1.1 Company		STMicroelectronics International N.V
1.2 PCI No.		ADG/22/13561
1.3 Title of PCI		H ² PAK-2 Leads (Pins) Modification
1.4 Product Category		see list
1.5 Issue date		2022-07-26

**H²PAK-2 (also called D²PAK HV) Leads (Pins) modification
at ST Shenzhen plant in China**

PCI Title : H²PAK-2 Leads (Pins) Modification

PCI Reference : ADG/22/13561

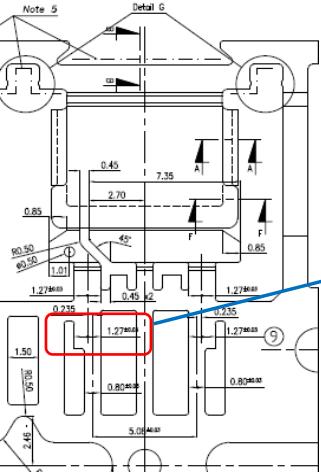
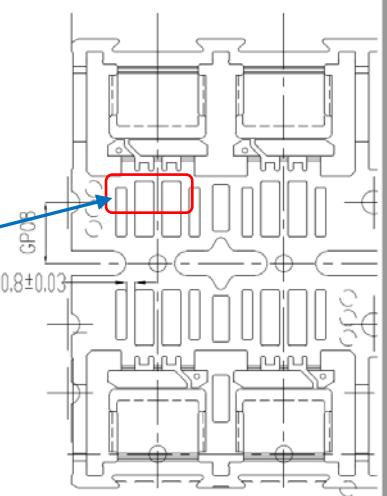
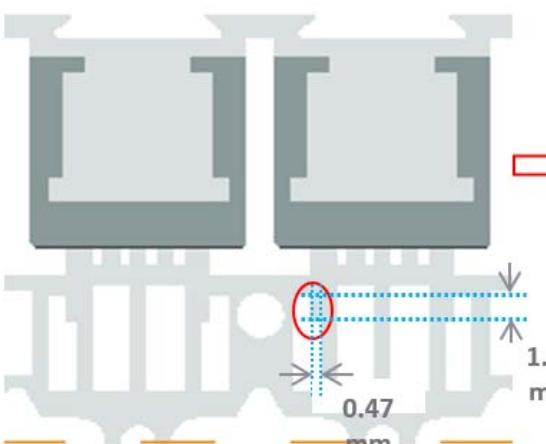
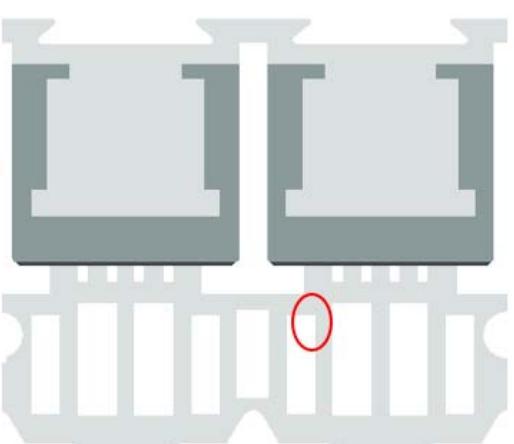
Following the continuous improvement of our quality performance, we would like to inform you about the Leads (pins) modification of H²PAK-2 (also called D²PAK HV) devices aimed to eradicate Tin burr risk due to frame lead design.

<table><tr> <th colspan="2">Units after dam bar cutting, before forming</th></tr></table>

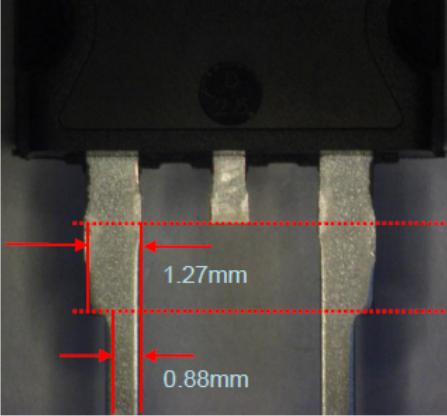
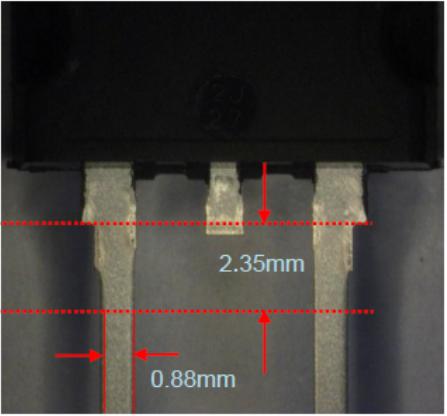
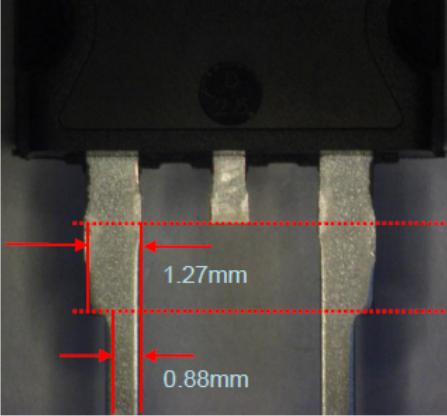
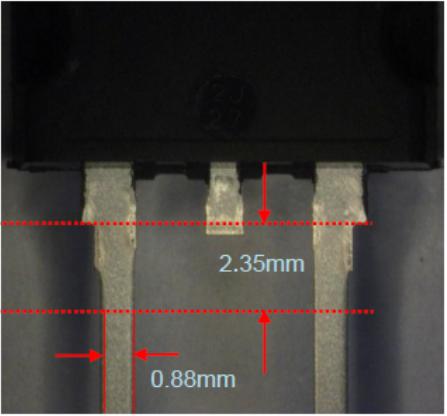
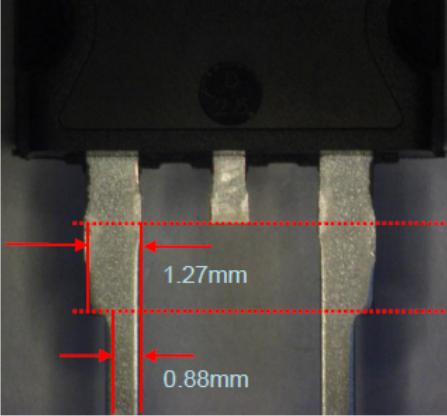
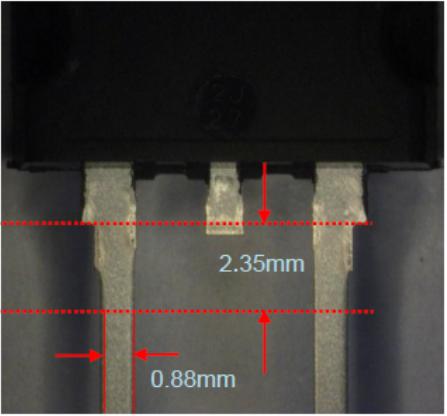
<table><tr> <th colspan="2">Units after dam bar cutting, before forming</th></tr><tr> <th>Former design</th><th>New</th></tr></table>
